Docket Item #5  
BZA CASE #2009-0001

Board of Zoning Appeals  
February 12, 2009

**ADDRESS:** 321 EAST RAYMOND AVENUE  
**ZONE:** R-2-5, RESIDENTIAL  
**APPLICANT:** ALABAMA LLC BY STEVE KOLINSKI, ARCHITECT

**ISSUE:** Variances to construct a one car garage in the required side and rear yards.

PHYSICAL IMPROVEMENTS SURVEY  
LOT 27, PART OF LOT 26, AND PART OF LOT 28

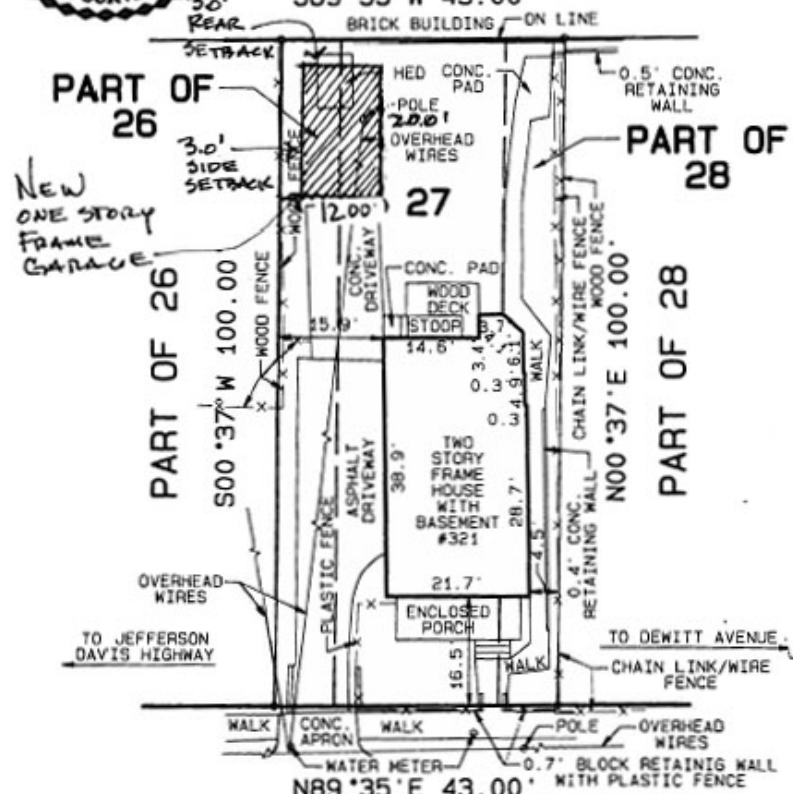
The applicant proposes to construct a detached one-car garage 3.00 feet from the rear property line and 3.00 feet from the east side property line. The garage measures 12.00 feet by 20.00 feet, totaling 240.00 square feet. The proposed garage building height will measure 11.25 feet to the midpoint of the roof gable.

The applicant requests a variance of 4.00 feet from the required 7.00 feet based on a building height of 9.58 feet measured to the eave of the roof of the proposed garage facing the east side property line. The proposed garage will be located 3.00 feet from the east side property line.

The applicant requests a variance of 4.00 feet from the required 7.00 feet based on a building height of 11.25 feet measured to the midpoint of the roof gable of the proposed garage facing the rear line. The proposed garage will be located 3.00 feet from the east side property line.
